Model: Russian-C		Date: 15-Dec-99	No.: RA265001
Subject: Quick dial problem		Prepared by: K. Miura	
From: Technical Services Dept., GTS Division			
Classification:	<input checked="" type="checkbox"/> Troubleshooting	<input type="checkbox"/> Part information	<input type="checkbox"/> Action required
	<input type="checkbox"/> Mechanical	<input type="checkbox"/> Electrical	<input type="checkbox"/> Service manual revision
	<input type="checkbox"/> Paper path	<input type="checkbox"/> Transmit/receive	<input type="checkbox"/> Retrofit information
	<input type="checkbox"/> Other (      )

Model: Russian-C1		Date: 15-Feb-00	No.: RA265002
Subject: Service Manual Correction		Prepared by: S. Tomoe	
From: Technical Services Dept., GTS Division			
Classification:	<input type="checkbox"/> Troubleshooting <input type="checkbox"/> Part information <input type="checkbox"/> Action required <input type="checkbox"/> Mechanical <input type="checkbox"/> Electrical <input type="checkbox"/> Service manual revision <input type="checkbox"/> Paper path <input type="checkbox"/> Transmit/receive <input type="checkbox"/> Retrofit information <input checked="" type="checkbox"/> Other (      )

This is to inform y

## 3.12. 1,000-SHEET FINISHER INSTALLATION (P 3-35)

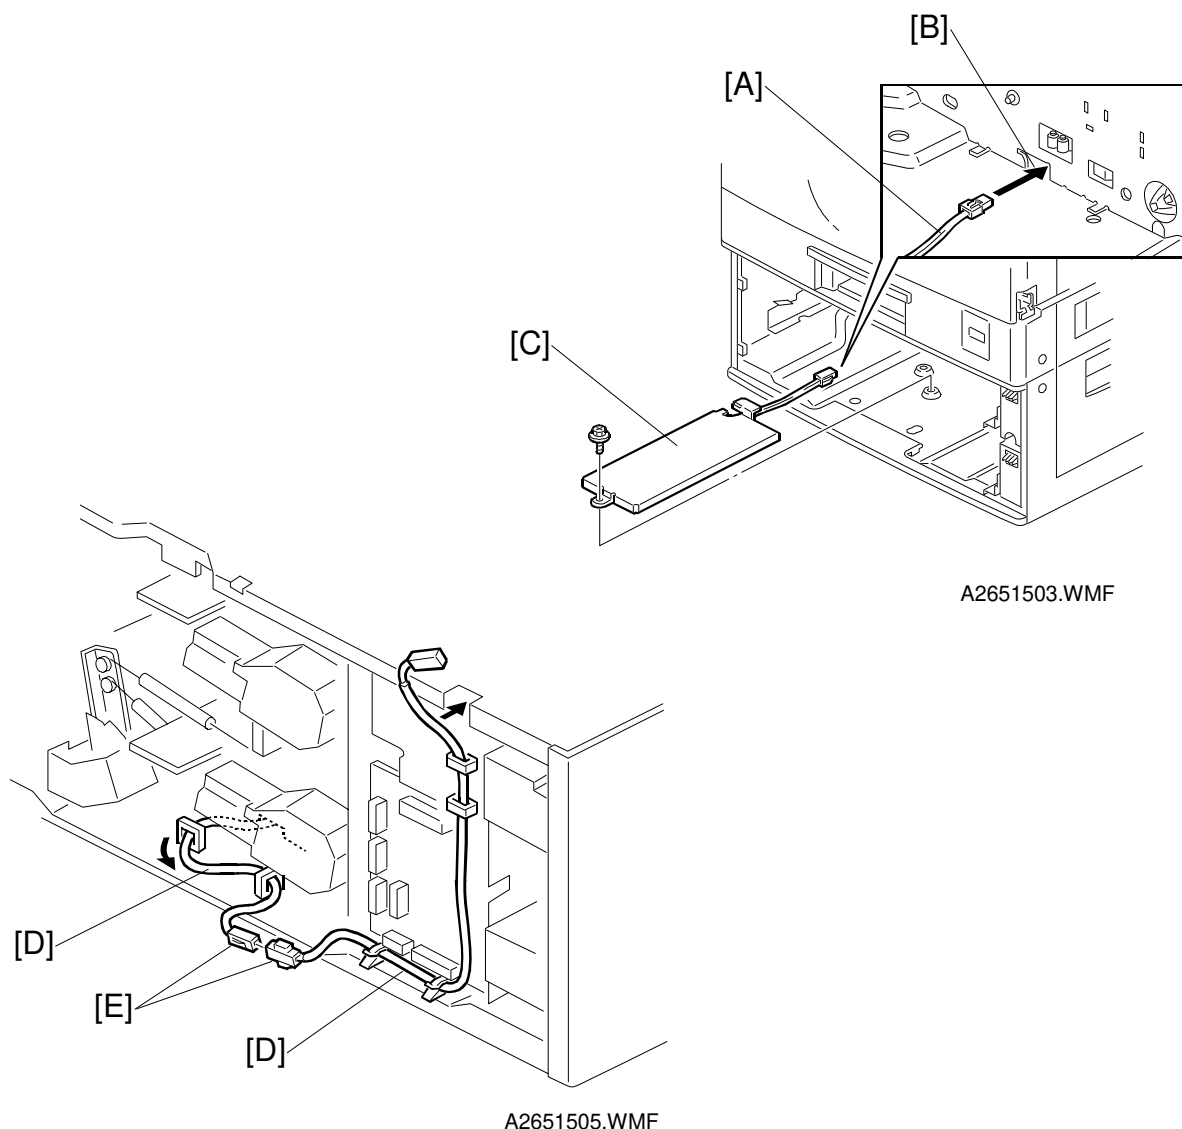
Delete Note no.2: "If this finisher will be installed on the A265 or A267 copier, ..."

## Examples:

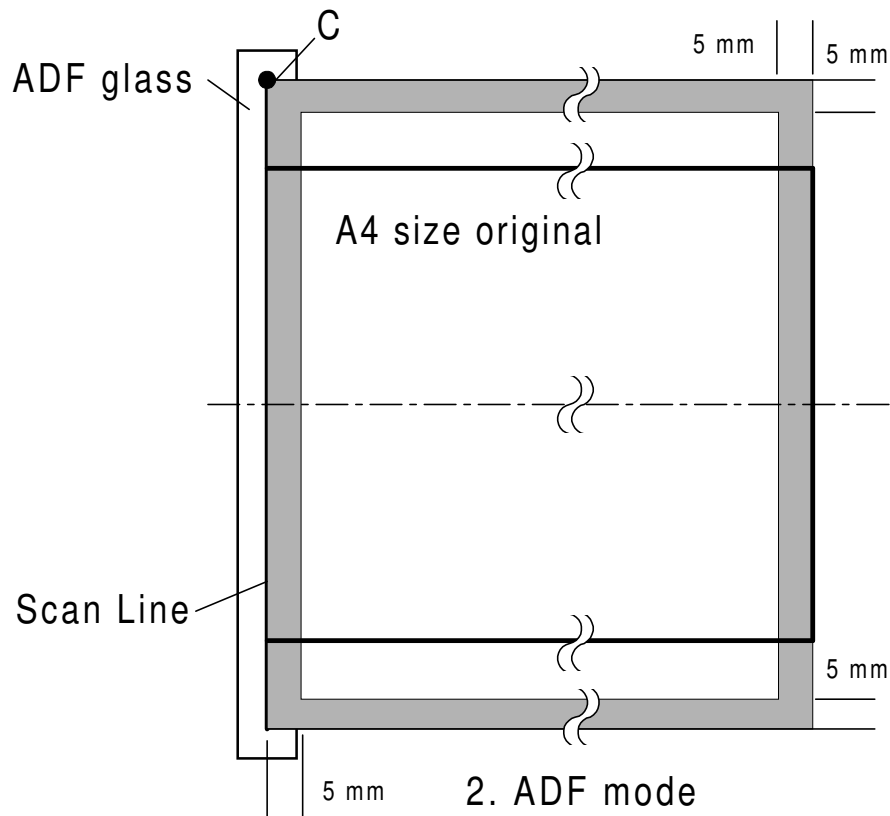
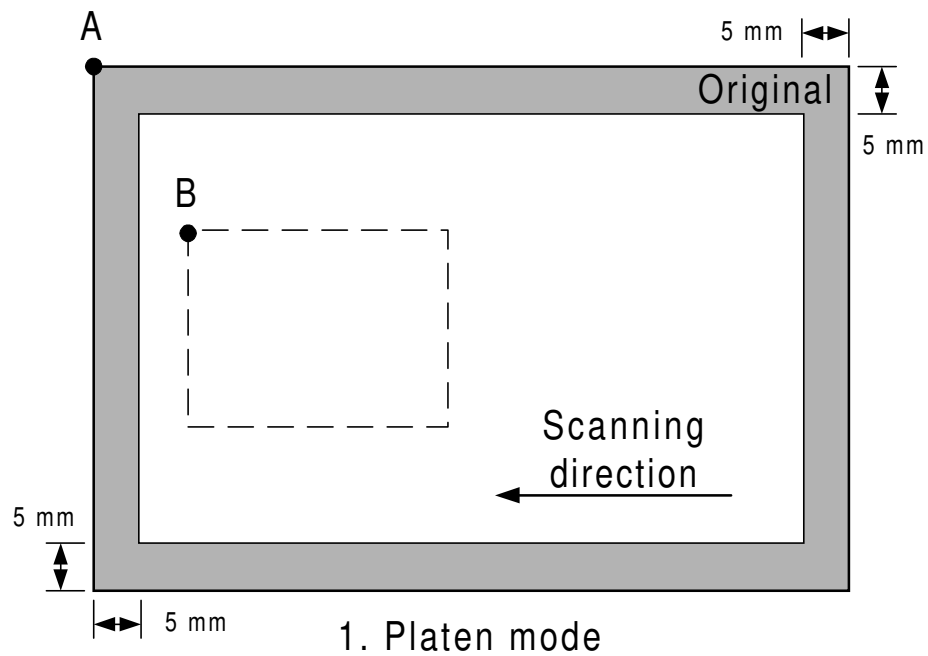
1. When the machine scans an A4 sized original in Platen Mode and the value of SP017 is 5 (illustration 1 below):

Since the scanning start position is at “A”, margins will be placed at 5 mm from the left and right edges (main scan) as well as from the leading and trailing edges (sub-scan). Any image within 5 mm of the four edges will be erased.

2. When scanning a selected area with the Preview function in Platen Mode and the value of SP017 is 5 (illustration 1):

Since scanning starts from point “B”, the 5 mm margin is not applied to the selected area, and nothing in this area is erased along either scan direction.

3. When the machine scans an A4 sized original in ADF mode and the value of SP017 is 5 (illustration 2):

In ADF mode, the original is centered along the main scan direction. Although the sub-scan direction margins are applied to the original (as in example 1), the main scan margins will not appear (left/right edges). This is because the machine applies the 5 mm main scan margin using reference point “C” (where scanning begins), and so the centered A4 original is too narrow for the main scan margin to appear.

Figure 1

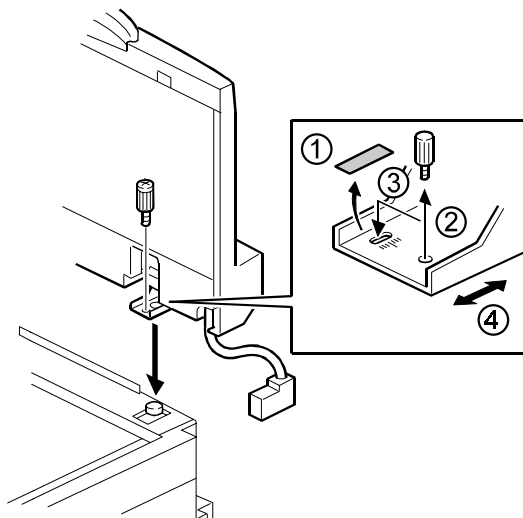
Skewed image on the original cannot be corrected even if the ADF position is changed (refer to figure 1).

The present shift range is not wide enough to completely correct the skew in some cases. The shift range is limited to 0.5 mm because the hinge is stopped by the scanner rear upper cover.

Figure 2

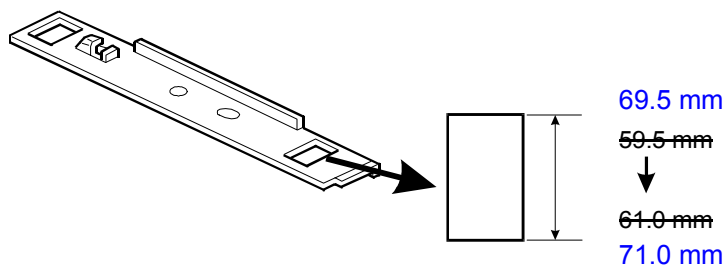
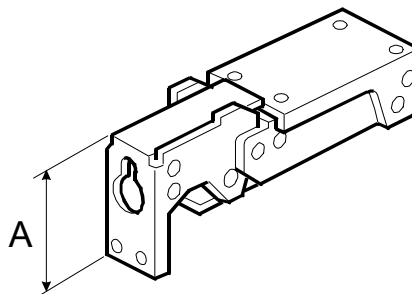
To expand the shift range, the bottom of the hinge has been shortened by 1 mm and the opening in the scanner rear upper cover has been expanded by 1.5 mm. See figure 2.

A: 58.5 mm → 57.5 mm

If the skewing on the original cannot be corrected, replace the scanner rear upper cover and/or the right hinge of the ADF.

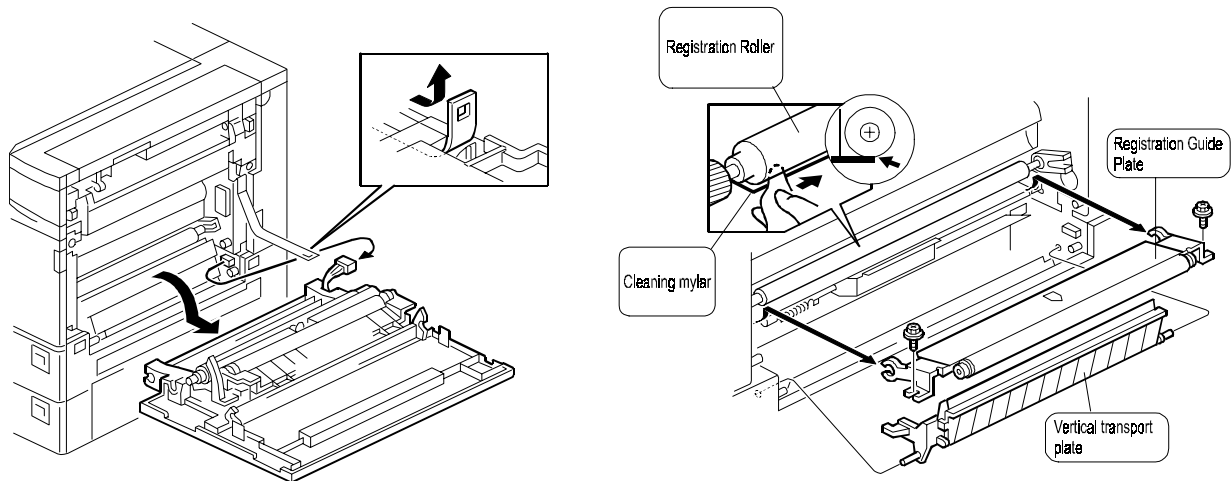
The Russian-C1 has toner recycling mechanisms. However, there are cases where broken black stripes can appear on copies when paper dust in this recycled toner builds up on the drum or charge roller surfaces. If the paper dust is on the charge roller surface, the stripe intervals will be in the pitch of the roller. The cleaning mylar, which contacts the registration roller, normally collects paper dust and prevents such copy problems. However, when there is an abnormally large amount of paper dust present, the mylar is not able to collect all of it, which can cause some to get into the PCU.

Clean out the paper dust that has accumulated between the dust cleaning mylar and registration roller:

1. Detach the support arm from the right cover, then remove the ID sensor connector and right cover.
2. Being careful not to scratch the mylar, slide the vertical transport guide plate to one side and remove it.
3. Remove the registration guide plate (2 screws).
4. Slide a piece of thick paper, or other material that will not scratch the roller, in between the registration roller and mylar. Then, while sliding the paper back and forth, remove the accumulated paper dust.

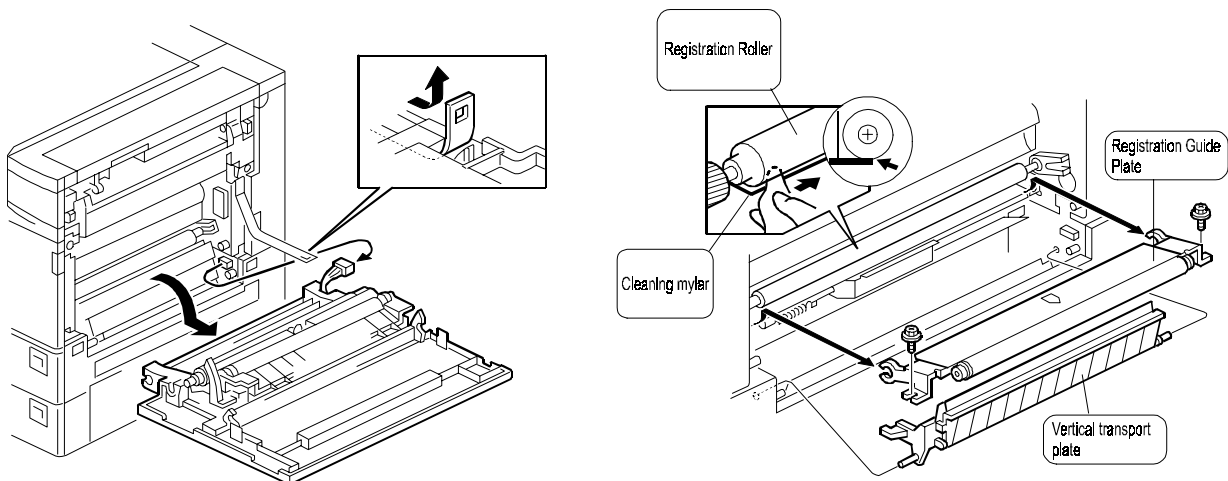
The Russian-C1 has toner recycling mechanisms. However there are cases where broken black stripes (see below) can appear on copies when paper dust in this recycled toner builds up on the drum or charge roller surfaces. If the paper dust is on the charge roller surface, the stripe intervals will be at the pitch of the roller. The cleaning mylar, which contacts the registration roller, normally collects paper dust and prevents such copy problems. However, when there is an abnormally large amount of paper dust present, the mylar is not able to collect all of it, which can cause some to get into the PCU.

Clean out the paper dust that has accumulated between the dust cleaning mylar and registration roller:

1. Detach the support arm from the right cover, remove the ID sensor connector and remove the right cover.
2. Being careful not to scratch the mylar, slide the vertical transport guide plate to one side and remove it.
3. Remove the registration guide plate (2 screws).
4. Slide a piece of thick paper, or other material that will not scratch the roller, in between the registration roller and mylar. Then, while sliding the paper back and forth, remove the accumulated paper dust.  
**Note:** Before doing this, be sure to place a piece of paper underneath the registration roller to prevent paper dust from getting on the paper feed rollers.
5. Clean the charge roller if possible.

Pull out Roller Guide

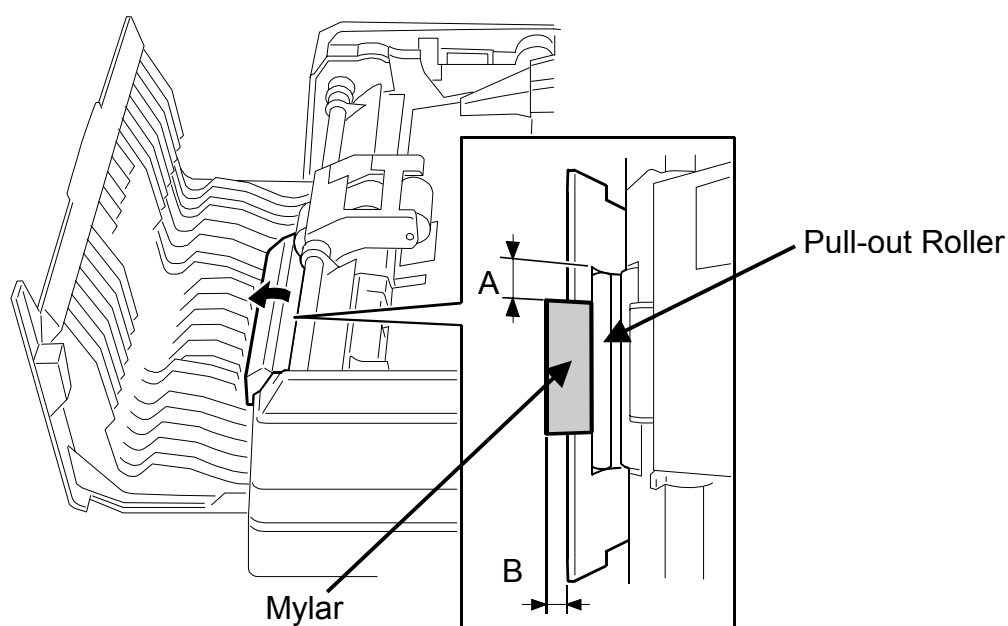
An original jam occurs if the leading edge contacts the pull-out roller guide while the second side is being scanned.

## Important Note for Hot Roller Replacement

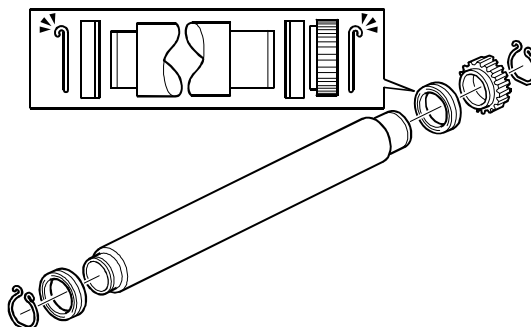
When you replace the hot roller, make sure to attach the C-ring in the **orientation shown below**. This helps the C-ring to hold the fusing roller more securely.
